9.0 TECHNICAL SPECIFICATIONS

The Technical Specification changes which are being requested in order to make the Calvert Cliffs Unit 2 Technical Specifications consistent with either the reference cycle (Reference 1) analyses which have been verified for Unit 2 Cycle 7 or the analyses contained herein are presented in this section. All changes except two which are being requested herein for Unit 2 were approved for Unit 1 in Reference 2. The first new change makes the affected Unit 2 Technical Specification identical to the corresponding Unit 1 Technical Specification. The second new change lowers the minimum DNBR Technical Specification limit to make it consistent with the final DNBR limit approved in Reference 3.

Calvert Cliffs 2 Cycle 7
Technical Specification Changes

Figure 3.2.3b

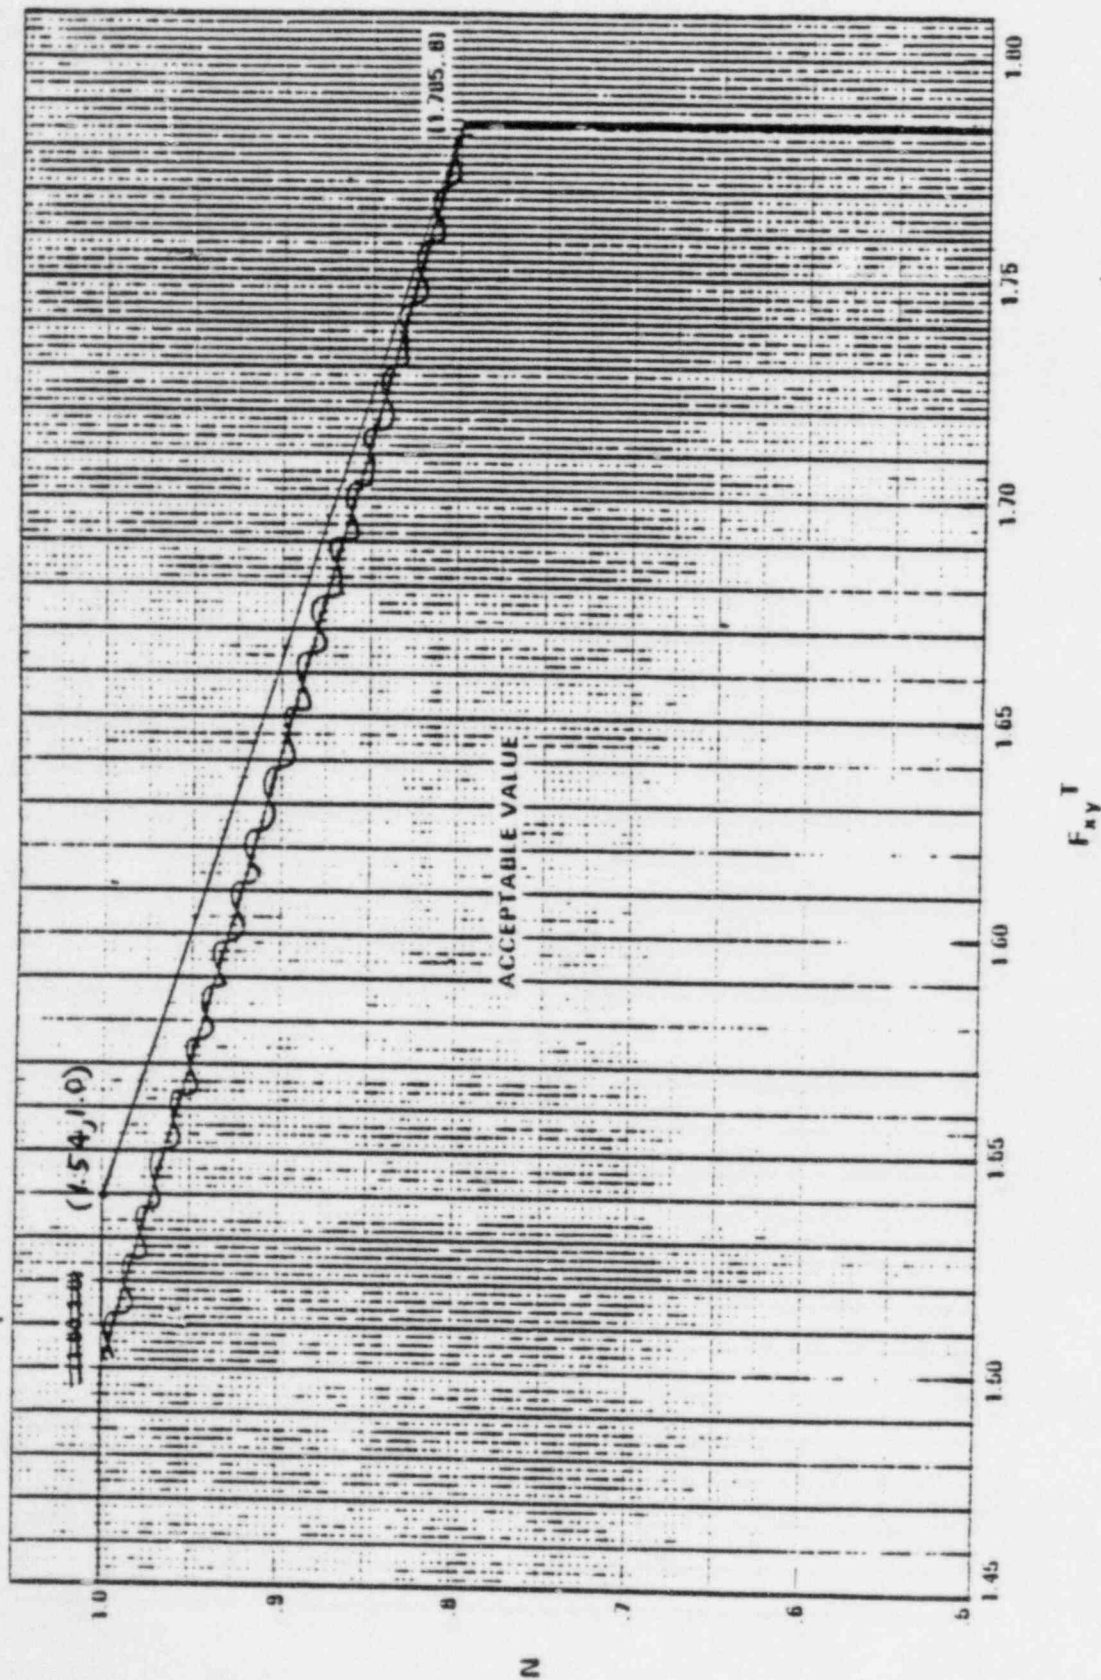
<u>Tech. Spec. No. and Page</u>	<u>Action</u>	<u>Explanation</u>	<u>Support</u>
4.2.1.4 (cont.)	Reduce the measurement- calculational uncertainty from 7.0% to 6.2%	This uncertainty is being reduced to conform to the approved value and to increase operating margin.	1) The new value is supported in Reference 7. 2) The thermal design analysis of the fuel pins presented in Section 4.3 supports this change.
	Reduce the axial fuel densification and thermal expansion factor from 1.0% to 0.2%	This uncertainty is being reduced to a level consistent with existing calculations and to increase operating margin.	The thermal design analysis of the fuel pins presented in Section 4.3 supports this change.
Figure 3.2-3b page 3/4 2-4a	Modify Figure 3.2-3b as indicated to increase the the radial peaking factor at which full power operation may proceed when operating on the excore monitoring system from 1.50 to 1.54	This radial peaking factor, in the form of the variable 'N', is being increased to make the Unit 2 Figure 3.2-3b identical to the correspond- ing Unit 1 figure and to increase operating margin.	The setpoint analysis for Unit 2 Cycle 7 supports this change.

FIGURE 4.2-1
Augmentation Factor vs
Distance from Bottom of Core

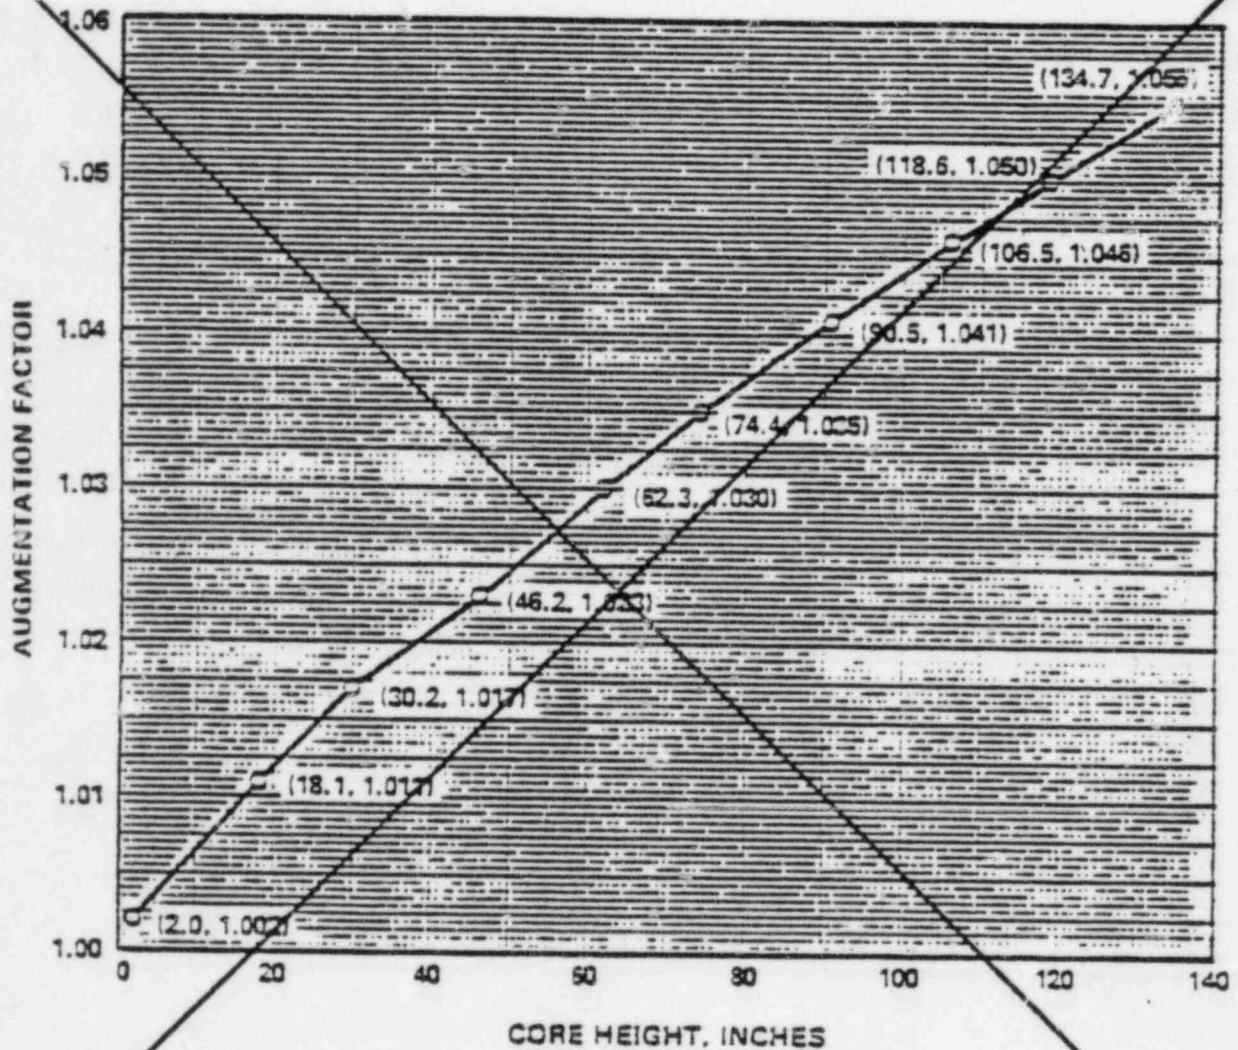
Figure 4.2-1 page 3/4 2-5	Delete Figure 4.2-1	See change for Tech. Spec. 4.2.1.4 which covers removal of flux peaking augmentation factor.	See change for Tech. Spec. 4.2.1.4 which covers removal of flux peaking augmentation factors.

DELETE
